This letter confirms our telephone conversation of this date regarding categories and possession limits of Radioactive Materials for License No. 06-00217-06.

Item 5 Radioactive Material

Subject: Response To Questions On Renewal Application

COMBUSTION ENGINEERING, INC.
Broad Scope Radioactive Materials
License Renewal Application
Responses To NRC Questions

**Figure 7.1-1
Organization Chart**

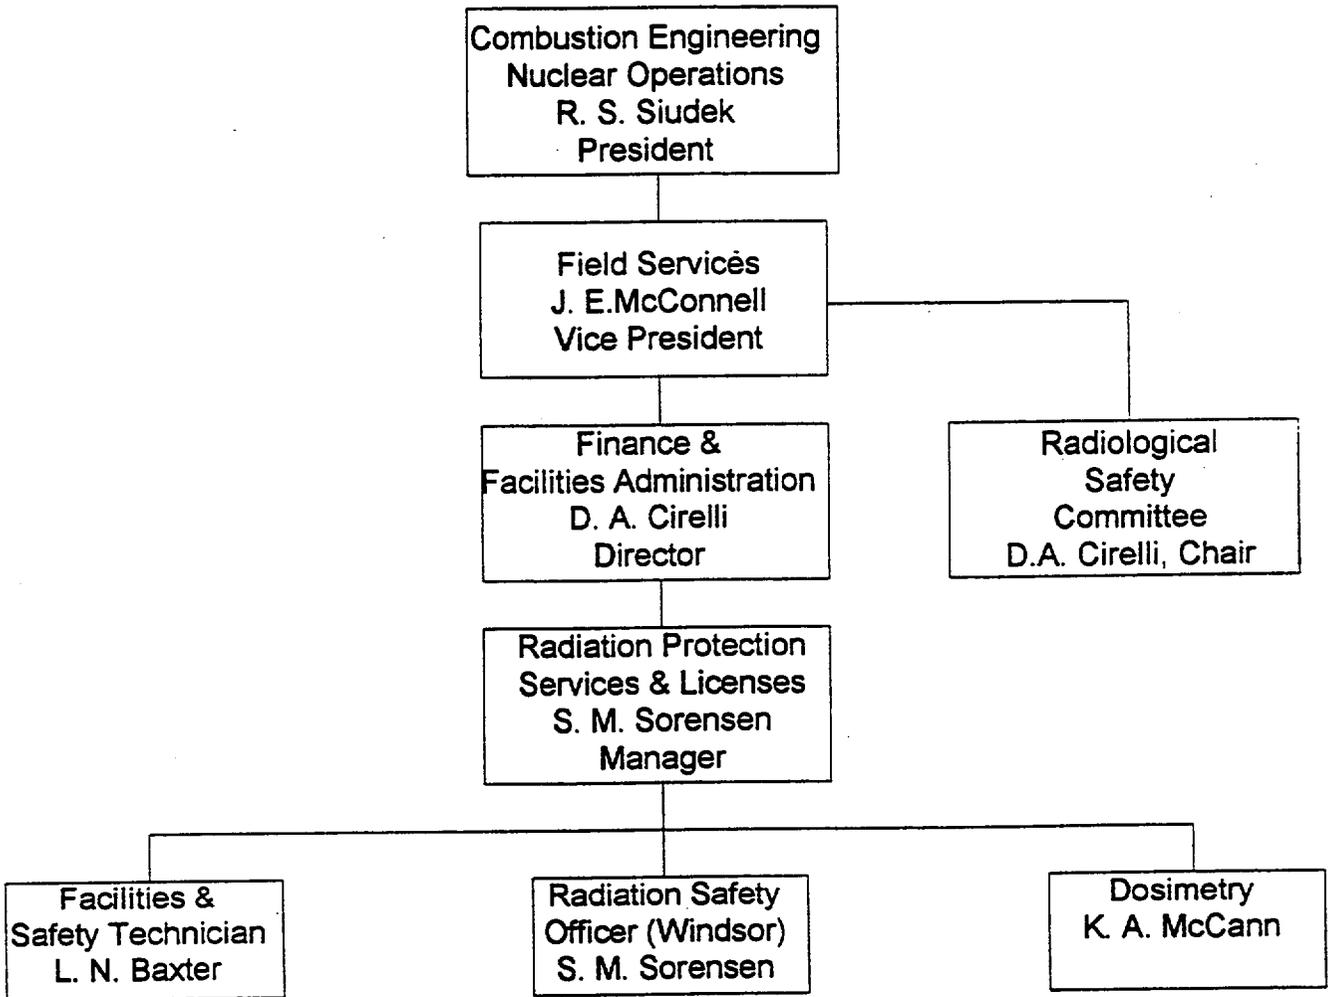
Figure 7.1.1 in your application shows the organizational structure of personnel involved with radiation safety. This figure does not include the RSC. Please revise this figure showing the organizational relationship of the RSC to senior management.

Figure 7.1.1 has been revised to show the reporting relationship of the RSC to senior management. Enclosure (4) contains the change page with the revised figure.

**Figure 9-10
Building 2 Cell 2 Control Zone Layout**

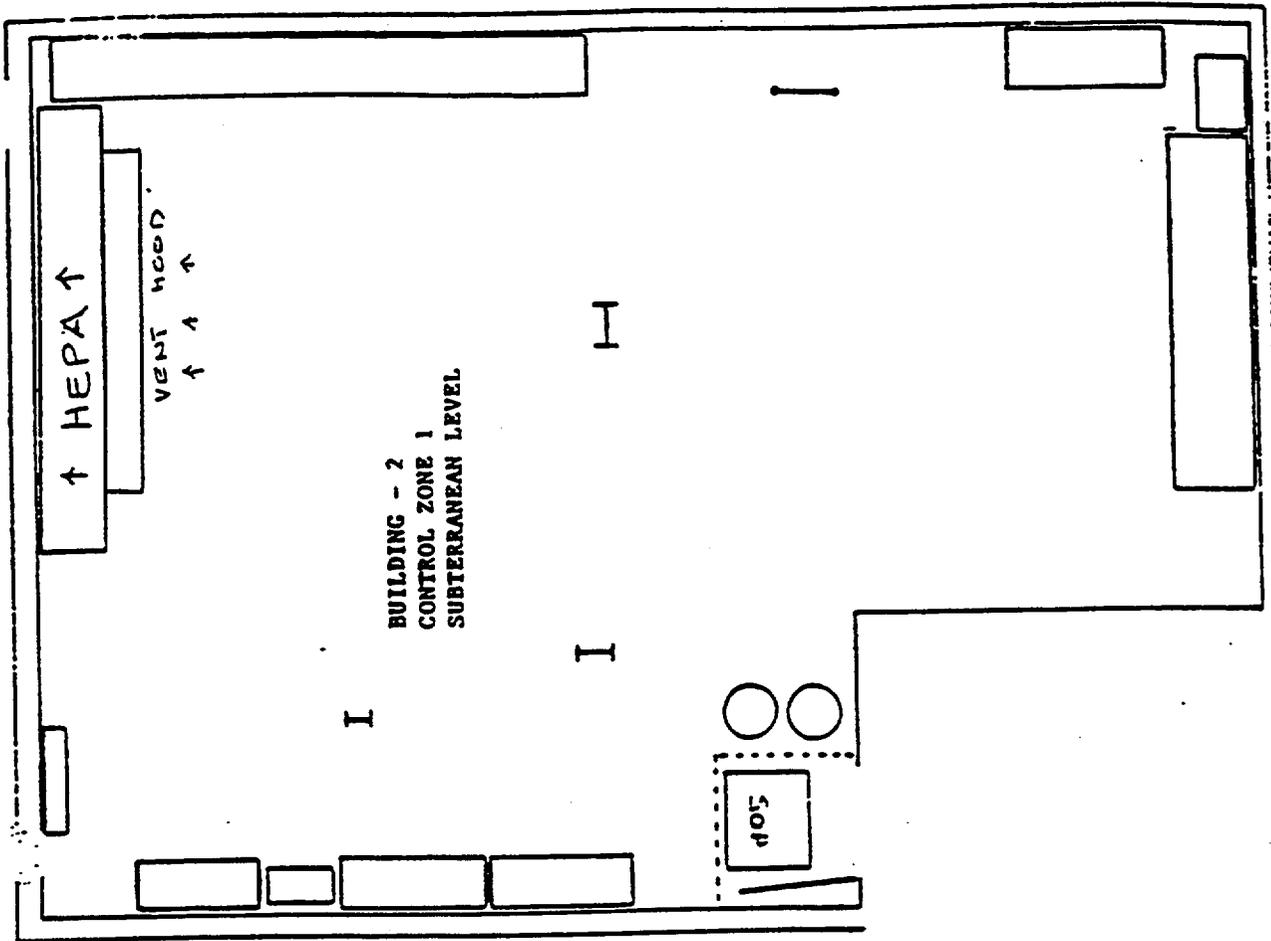
Item 2. The location of the effluent release point on Building #2 has been noted on Figure 9-10. The release points on Building #5 are shown in existing Figures 9-12 through 9-14. Enclosure (4) includes the revised Figure 9-10 on page 35.

**Figure 10.7-1
Onsite Environmental Sampling Locations**

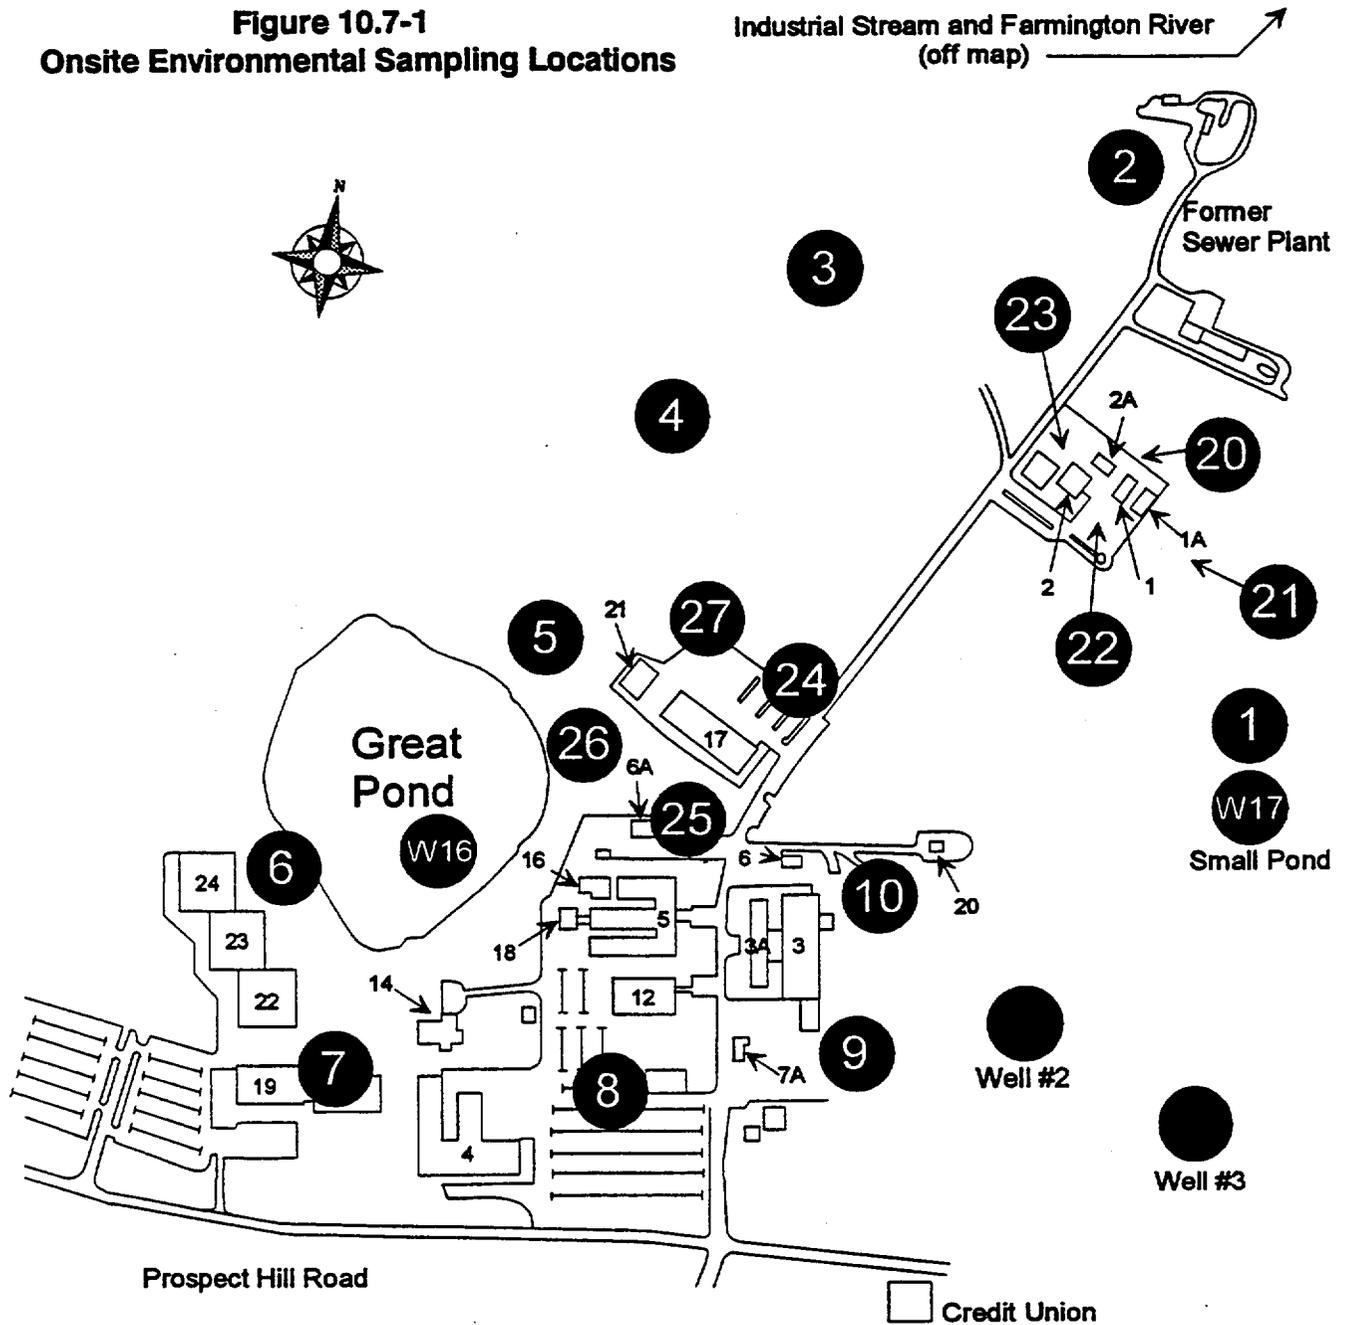
Section 10.7 of your application describes your environmental monitoring program for the Windsor site. With regard to your environmental monitoring program, please provide the following information:

Maps of the Windsor facility, the surrounding area and monitoring locations have been added as Figures 10.7-1 and 10.7-2 on pages 60b and 60c and they are referenced in text added to a newly titled Section 10.7.1 on page 60. Note that the nearest receptor location is not shown since the more limiting boundary of the restricted area is currently employed for demonstration of compliance. Enclosure (4) contains change pages with the figures.

Figure 10.7-7A
Topographic Map of Site Area

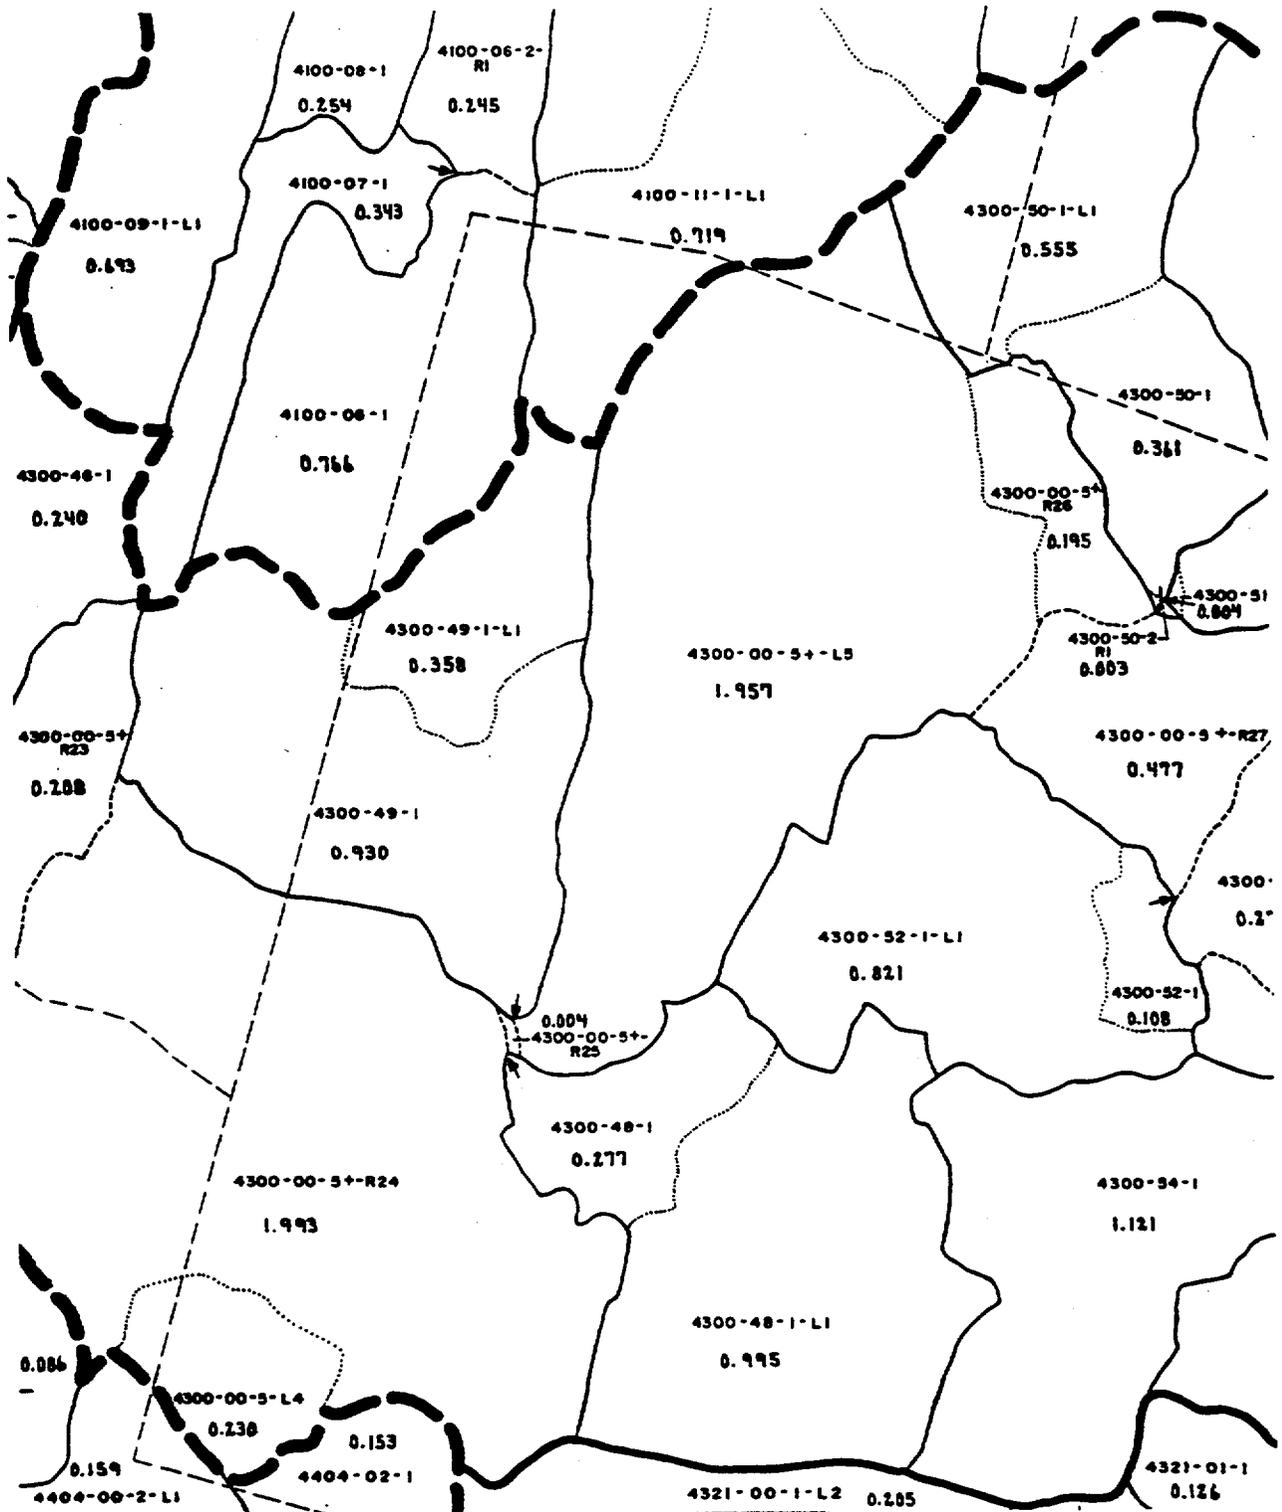
- e. For each groundwater monitoring location, depth of well from surface, depth from surface of the well's screened portion, and formation sampled (i.e. overburden, bedrock).
 - f. Map(s) indicating the current direction of groundwater flow in the overburden and bedrock.
11. Your ALARA program described in Section 10.8 does not appear to include effluent releases. Please revise your ALARA program to include effluents from your facility. You may find Regulatory Guide 8.37 (enclosed) helpful in preparing your response.
12. 10 CFR 20.1302(b) requires that the licensee show compliance with the annual dose limits in 10 CFR 20.1301. Describe your procedure for demonstrating compliance with 10 CFR 20.1301. If your procedure uses calculations or use of pathway models, please provide sample calculations or the name(s) of specific references or models utilized.

A topographic map of the site area is added as Figure 10.7-7A (State of Connecticut, Department of Environmental Protection Natural Resources Center, DEP Bulletin 17A). The site is located in the bottom center of this map and may be recognized from the site layout shown in Figure 10.7-1. Drainage basins for the same area as shown on the topographic map and to the same scale are shown on Figure 10.7-7B (Connecticut DEP map, Natural Drainage Basins, Windsor Locks Quadrangle No. 22). These maps have been referenced in Section 10.7 and are included as change pages 60i and 60j of Enclosure (4).
